Re: Petition No. Petition 1226 - Towantic Switch Station and Line Project

Response to CSC-01 Interrogatories dated 04/28/2016

**CL&P dba Eversource Energy**  
**Petition No. Petition 1226**

TOWANTIC 3P  
SITE DEVELOPMENT  
CIVIL PLAN & DETAILS  
OXFORD, CT

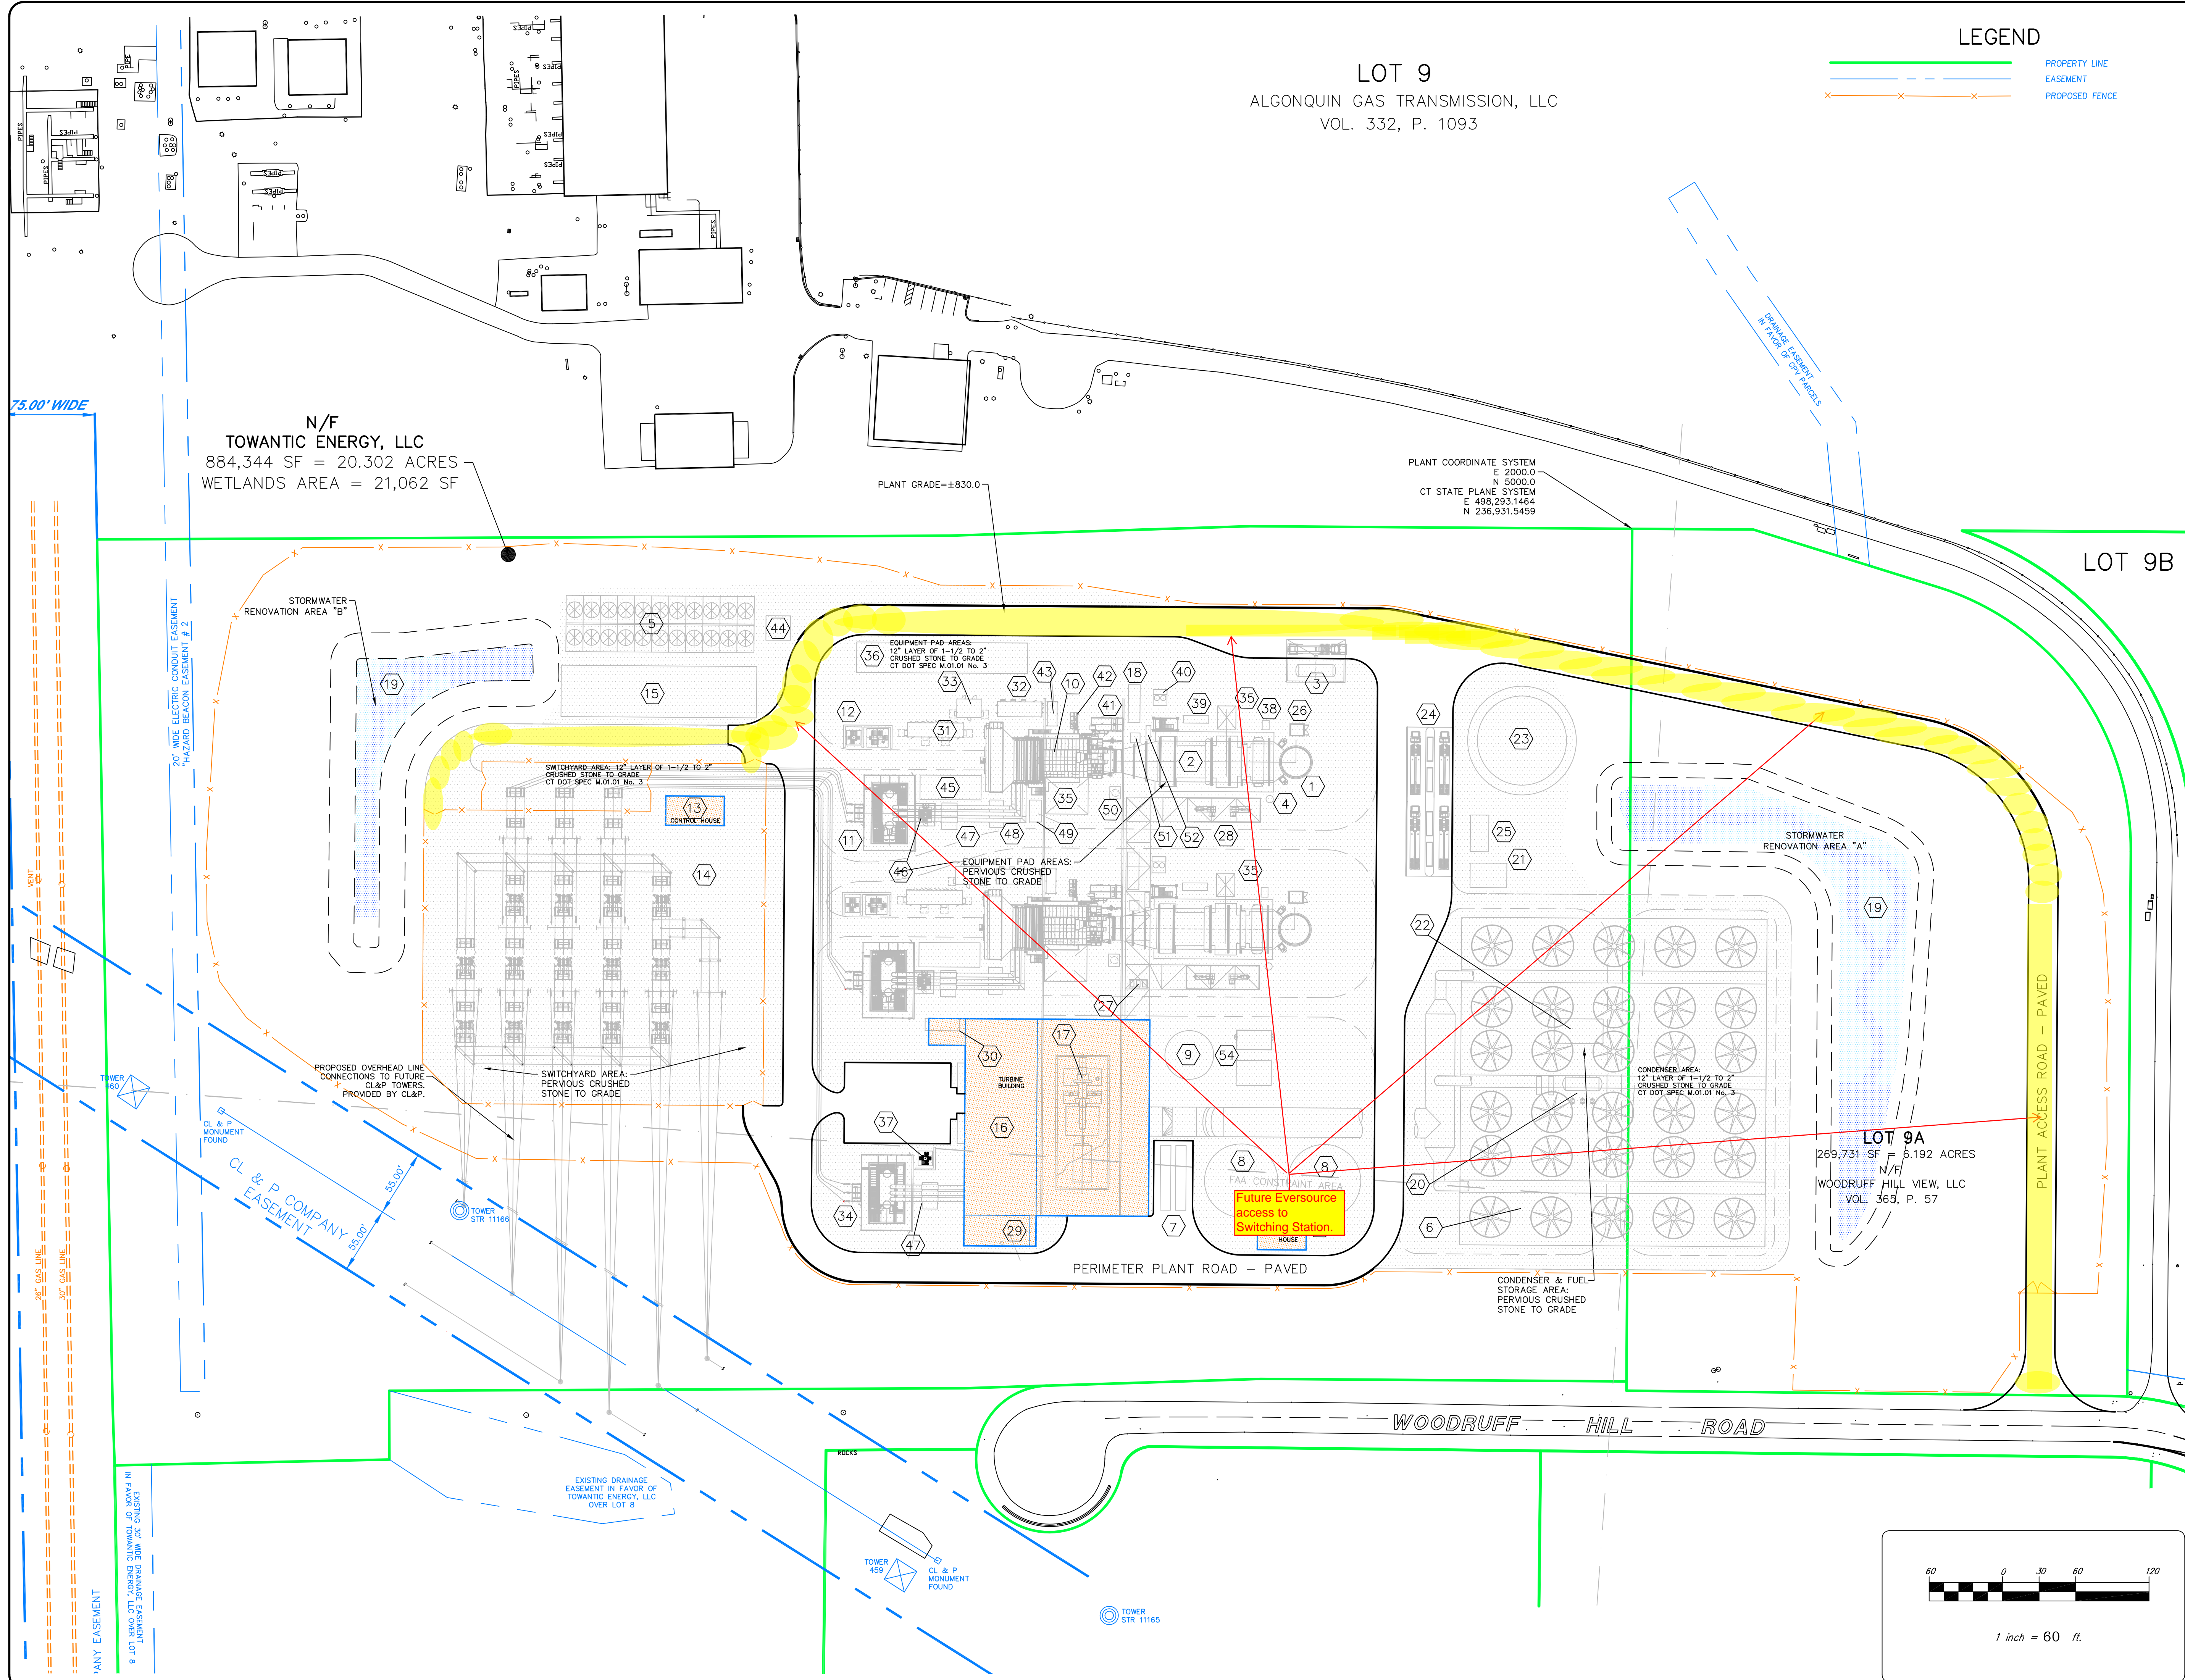
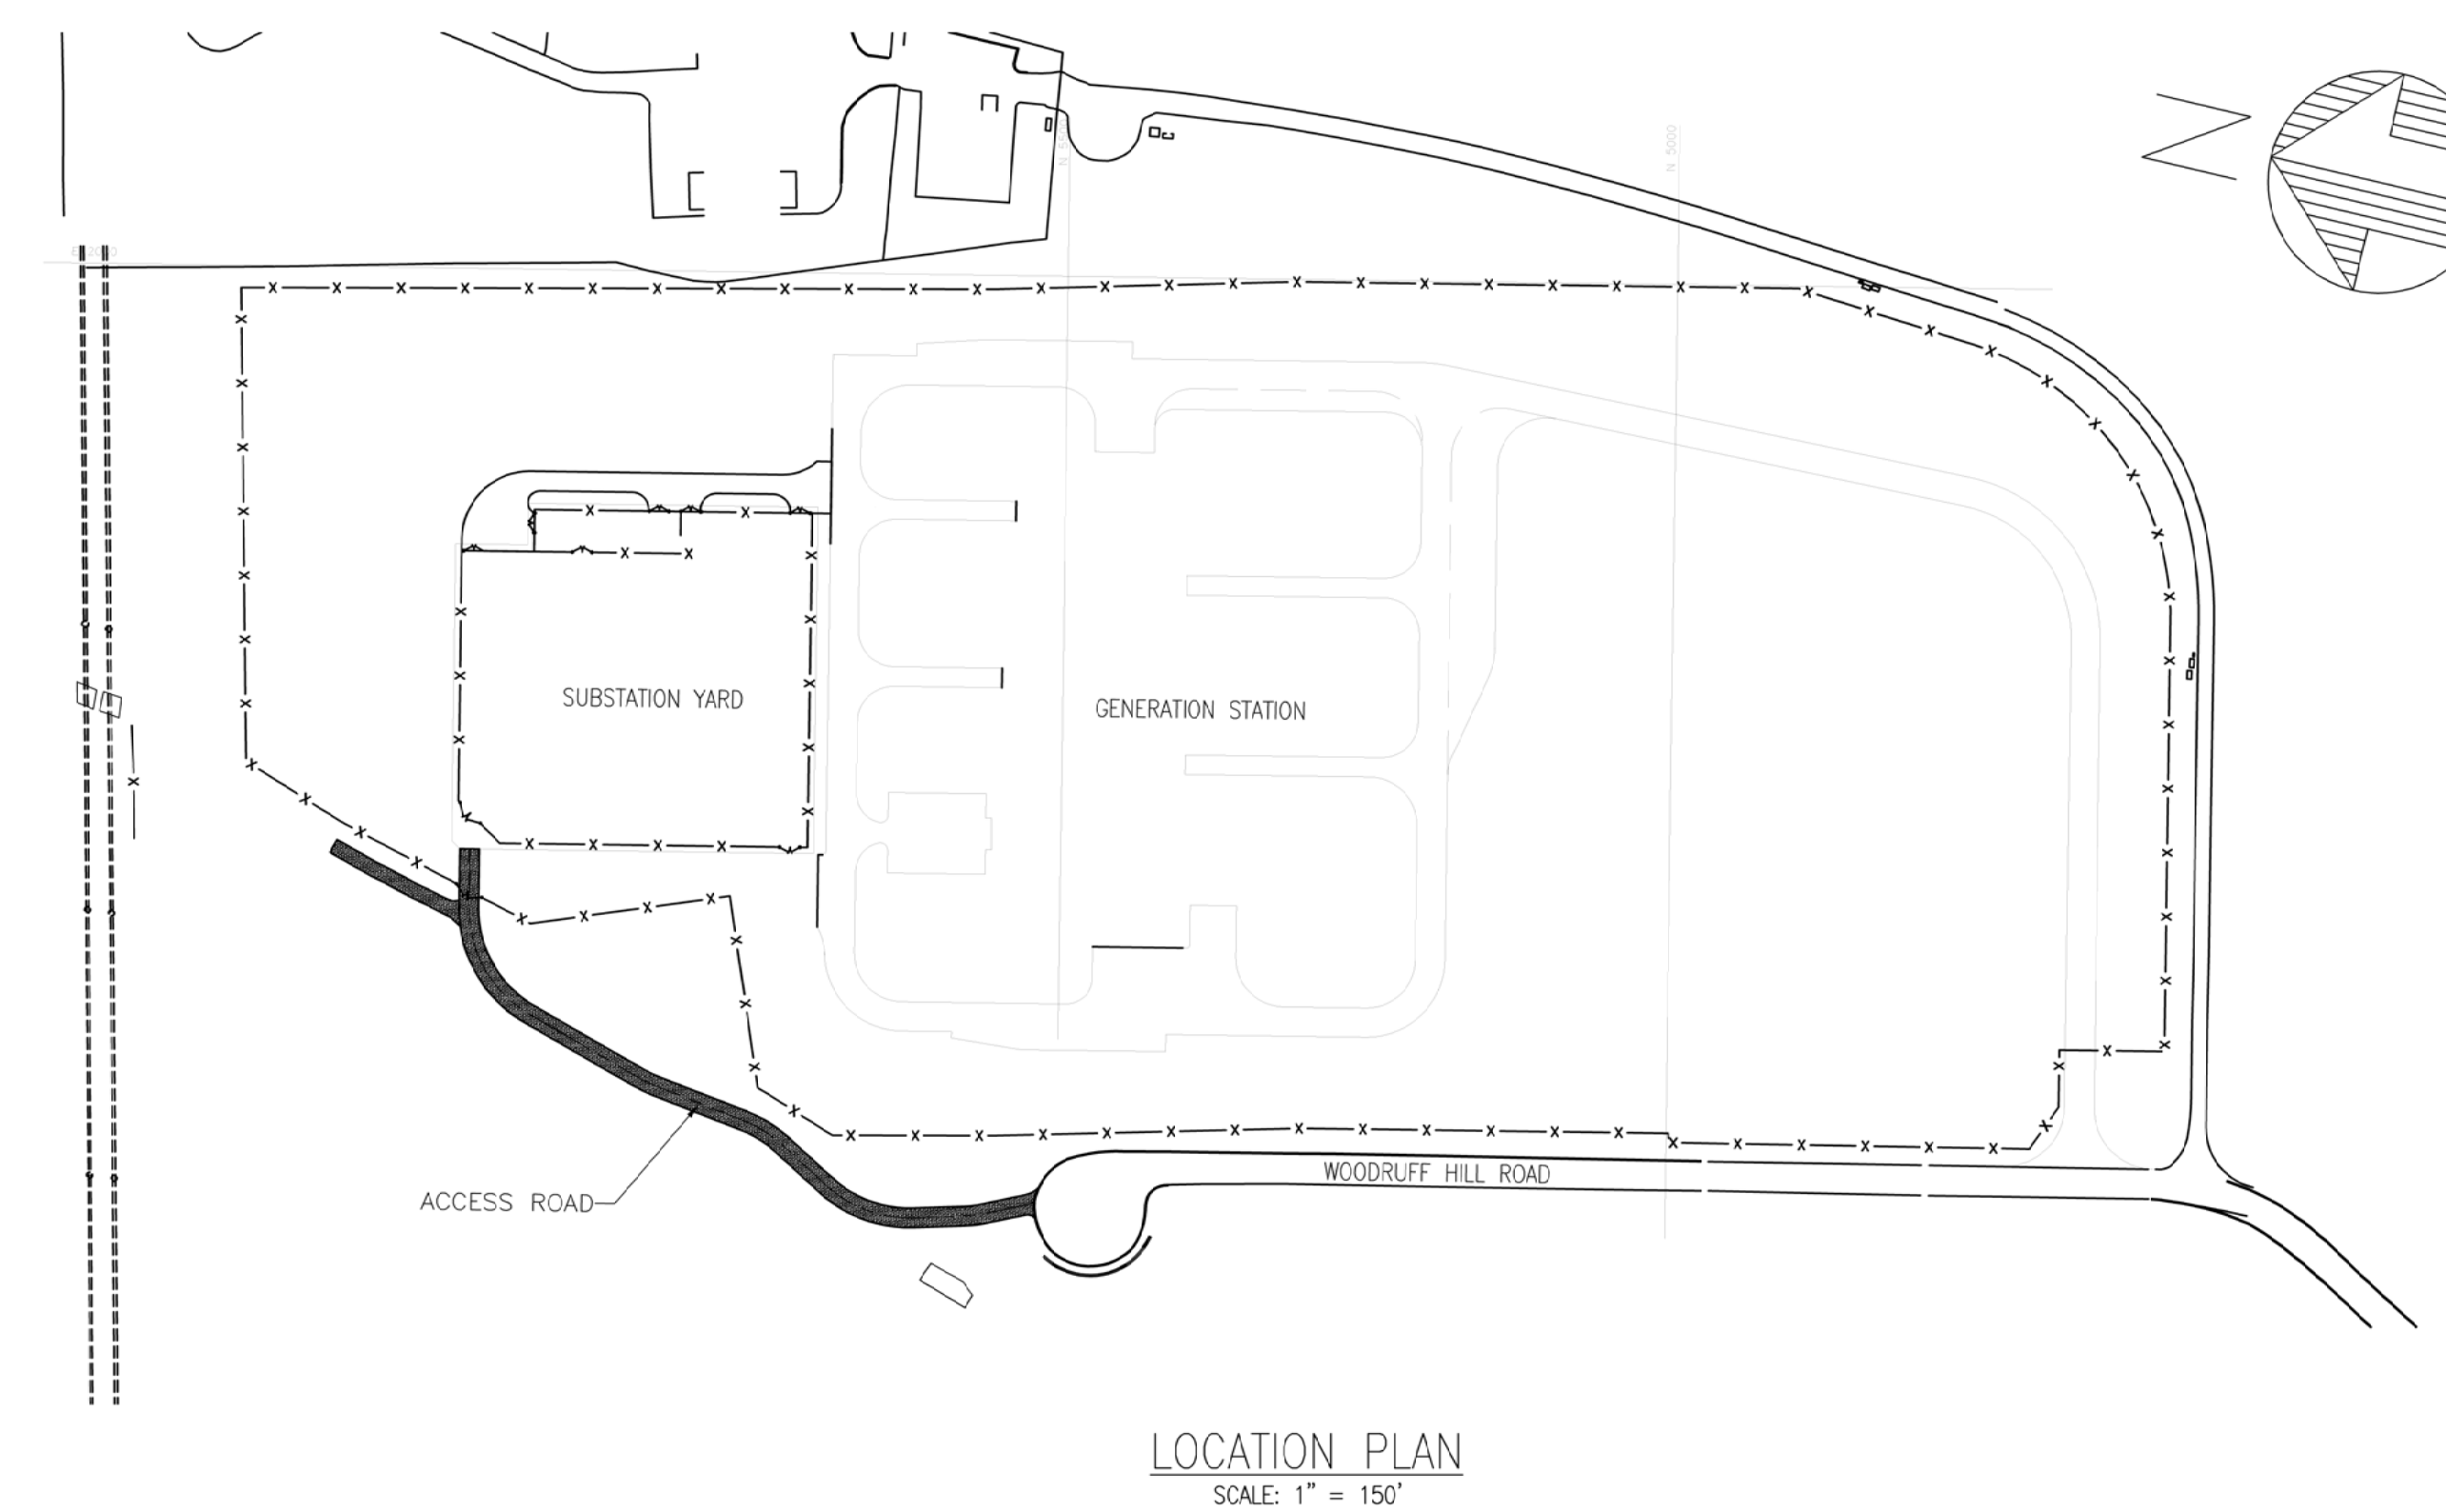
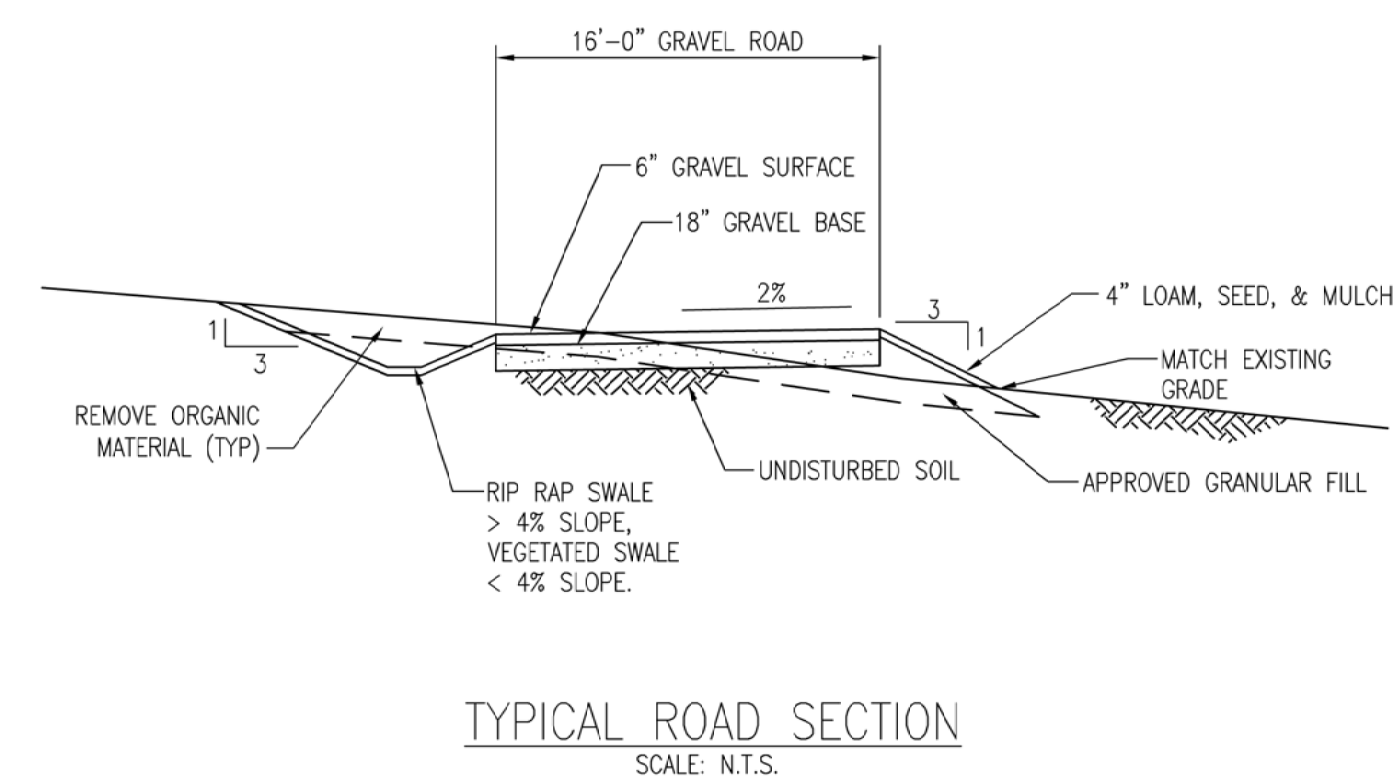
Provide a simplified drawing (or aerial photo) depicting existing versus proposed access to the switching station itself. Would all new and/or improved access be gravel? Provide the total length of the access to the switching station.

The proposed permanent access to the Switching Station will be comprised of a primary access route and a secondary access route. The existing access to the area where the Switching Station will be located is from the Woodruff Hill Road cul-de-sac utilizing the existing ROW gravel access road. The attached aerial photo has been marked-up to indicate the existing access route. The total length from the Woodruff Hill Road cul-de-sac to the Switching Station area via the existing access route is approximately 500 feet. The primary access route will utilize the proposed CPV Towantic paved main access road as shown on the attached, marked-up Drawing #C305. The total length from Woodruff Hill Road to the Switching Station is approximately 1,500 feet. The secondary access route will utilize the modified ROW gravel access road as shown on the attached, marked-up Drawing # 20806-11001. The total length from the Woodruff Hill Road cul-de-sac to the Switching Station area via this secondary access route is approximately 620 feet.
